**VIRGINIA ELECTRIC AND POWER COMPANY  
PROPOSED TECHNICAL SPECIFICATION REVISION**

**FΔh INCREASE/STATISTICAL DNBR METHODOLOGY -  
AFFECTED TECHNICAL SPECIFICATION PAGES**

**VIRGINIA ELECTRIC AND POWER COMPANY  
PROPOSED TECHNICAL SPECIFICATION REVISION**

**FΔh INCREASE/STATISTICAL DNBR METHODOLOGY -  
DISCUSSION AND SAFETY EVALUATION OF PROPOSED CHANGES**

TS FIGURE 2.1-1

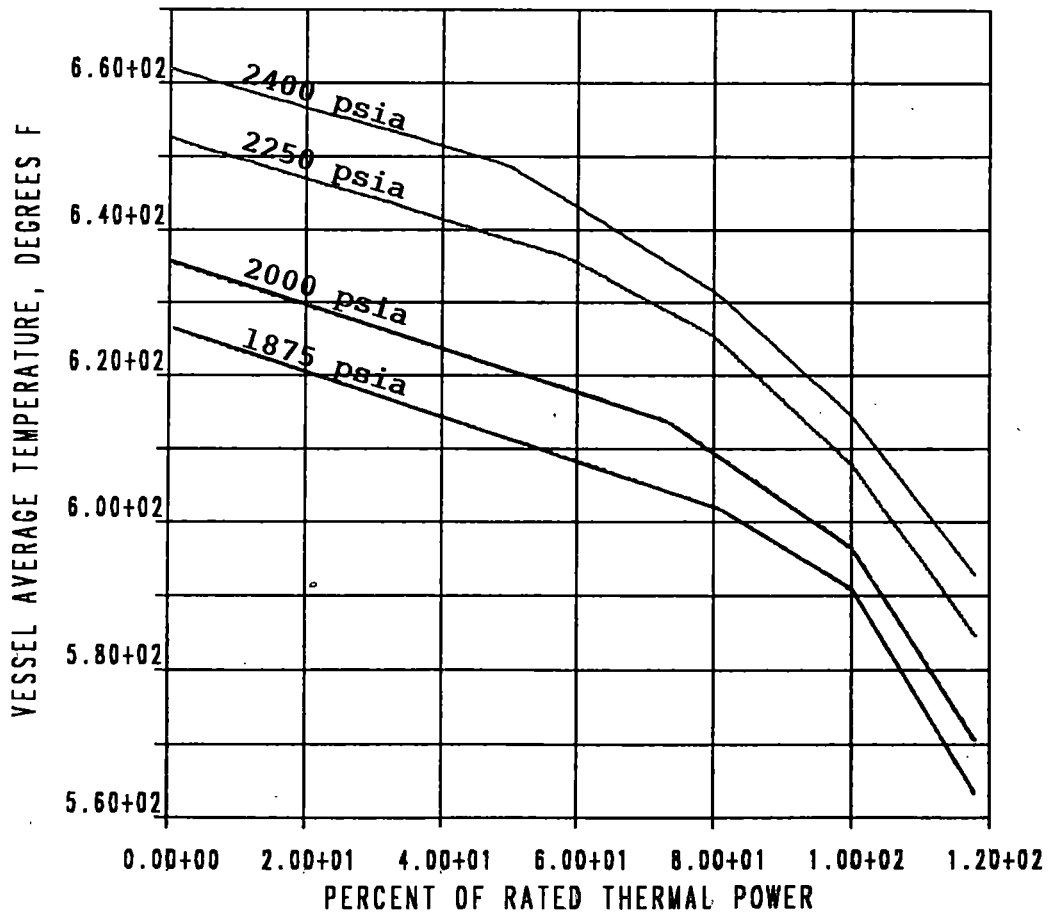
TS Figure 2.1-1 is based on an  $F\Delta H(N)$  of 1.62, a 1.55 cosine axial flux shape, and a deterministic DNB analysis procedure including margin to accommodate rod bowing<sup>(1)</sup>. TS Figure 2.1-1 is also bounding for a statistical treatment of key DNBR analysis parameter uncertainties including an enthalpy rise hot channel factor which follows the following functional form:  $F\Delta H(N) = 1.56 [1 + 0.3(1-P)]$  where P is the fraction of rated power. TS Figures 2.1-2 and 2.1-3 are based on an  $F\Delta H(N)$  of 1.55, a deterministic treatment of key DNB analysis parameter uncertainties, and include a 0.2 rather than 0.3 part power multiplier for the enthalpy rise hot channel factor.

- TS 2.1 Bases updated to reflect new  $F\Delta h$  limit (page 2.1-4)
- TS Figure 2.1-1 (Reactor Core Thermal and Hydraulic Safety Limits) revised
- TS 3.12.B.1 updated to reflect new  $F\Delta h$  limit (page 3.12-3)
- TS 3.12.B.1.a updated to reflect new  $F\Delta h$  limit (page 3.12-3)
- TS 3.12 Basis updated to reflect new  $F\Delta h$  limit (page 3.12-15 and 3.12-16)
- TS Figure 3.12-8 ( $K(z)$ ; Normalized  $FQ(z)$ ) revised

TS FIGURE 3.12-8

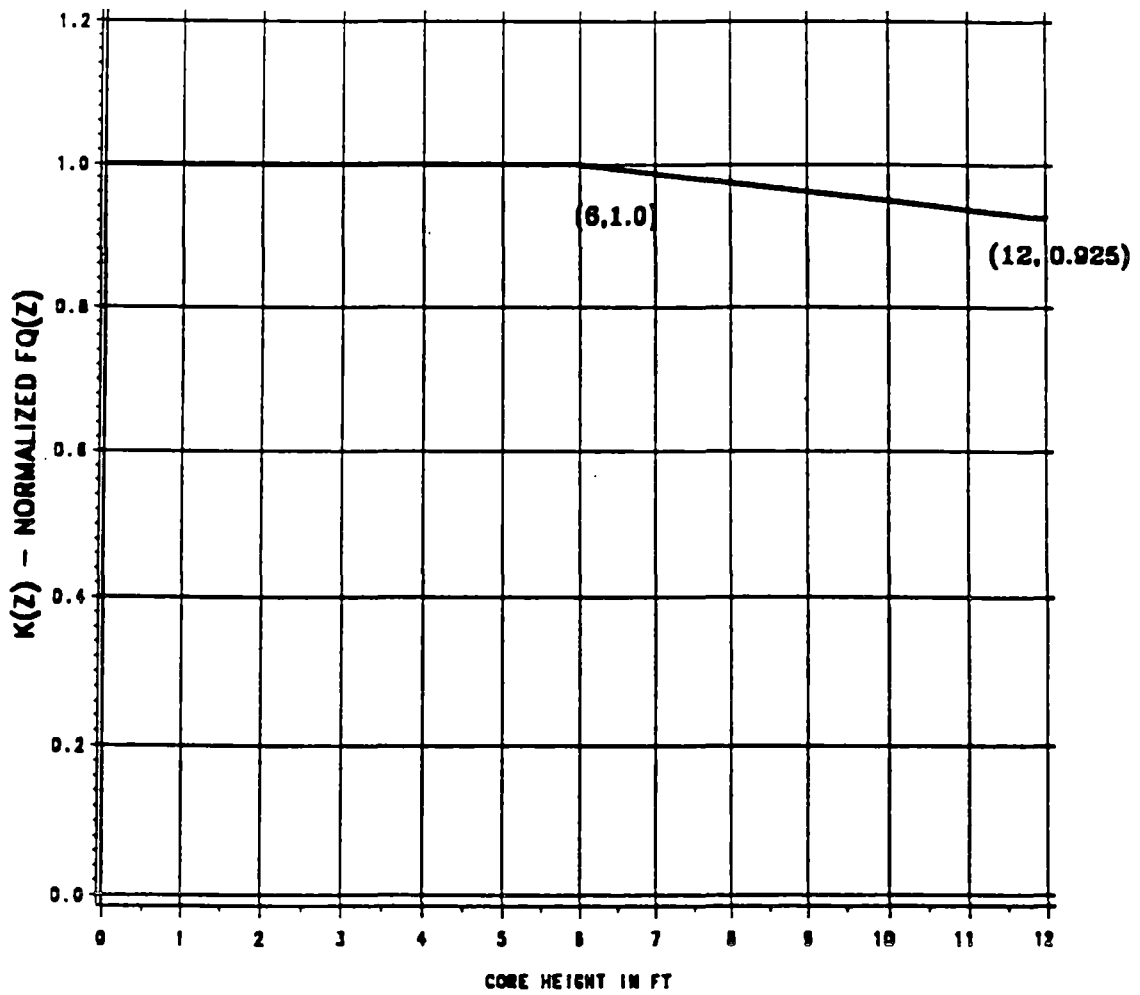
This analysis also employed a revised  $K(z)$  envelope, the hot channel factor normalized operating curve shown in Figure 6.0-2.  $K(z)$  is a

multiplier on the allowable 3-D peaking factor  $FQ$ , and by nature cannot exceed 1.0. The current Surry  $K(z)$  curve consists of three linear, continuous segments, of which the uppermost is defined by small break LOCA concerns. However, in this small break LOCA analysis, the uppermost line segment has been eliminated by the use of a revised hot rod axial power shape (shown in Figure 6.0-3) in the LOCTA-IV code. This power shape has been chosen from a generic database of potential shapes achievable during power operation by assessing the characteristics which yield limiting small break LOCA results. The selected shape has been identified as the most limiting within the bounds of the proposed  $K(z)$  curve. For each reload core, the revised Technical Specifications  $K(z)$  curve will be confirmed to provide a limit which defines acceptable bounds for axial power shapes. This confirmation will be performed by assessing the impact of achievable shapes upon all transients for which axial power shape is a key analysis input.

Figure 4.3-1

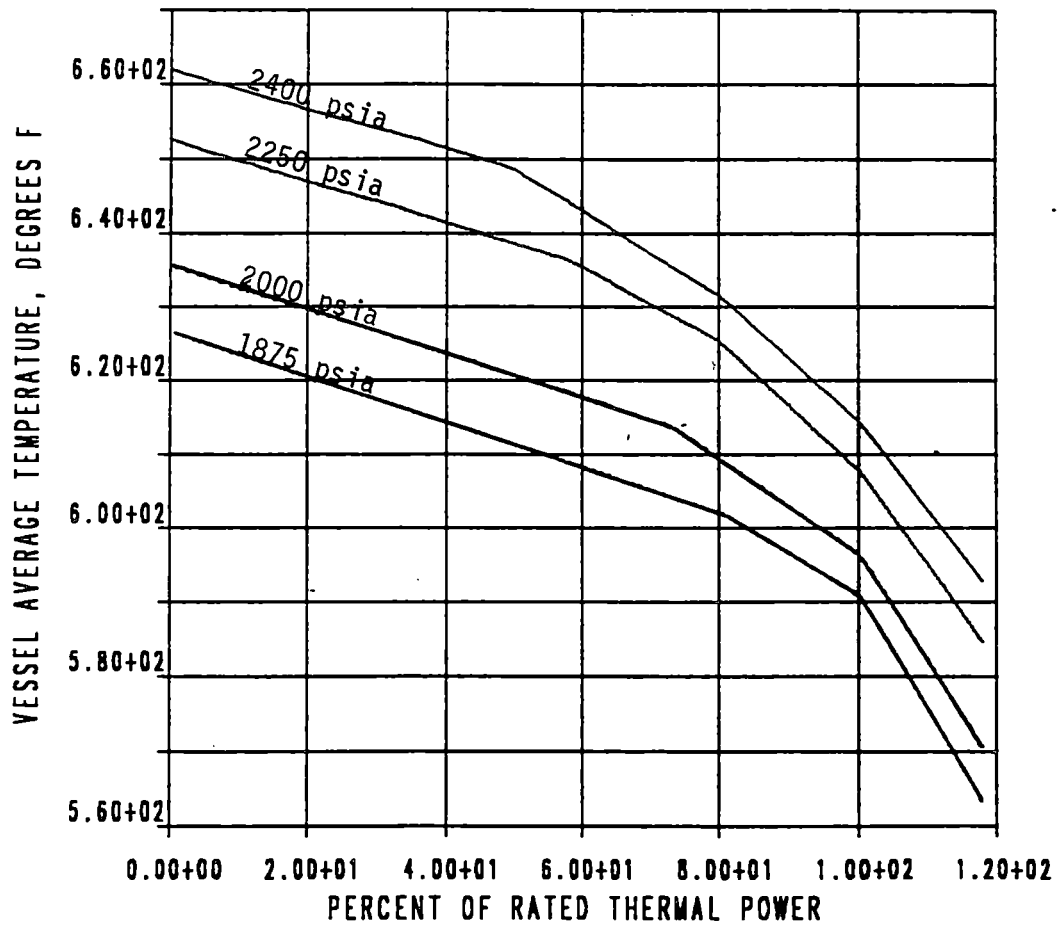
The new core thermal limits are plotted in Figure 4.3-1 and are included in the proposed revised Technical Specifications. They do not differ by very much from the current Technical Specifications CTL's; however, they are in some cases slightly less conservative, so that it is necessary to note that the new limits are not entirely bounded by the current limits. The major changes are a result of the impact of the higher 1.62 FΔh on the 15% hot channel exit quality limit.

Conveniently, however, the new core thermal limits are still bounded by the current OTΔT trip function. At the statepoints where the LOPAR/1.62 FΔh CTL's were more limiting than the current Technical Specification CTL's, the OTΔT margin was sufficiently large to absorb the difference. The current OTΔT trip function, including the F(ΔI) function, therefore remains unchanged for LOPAR fuel with a 1.62 FΔh.
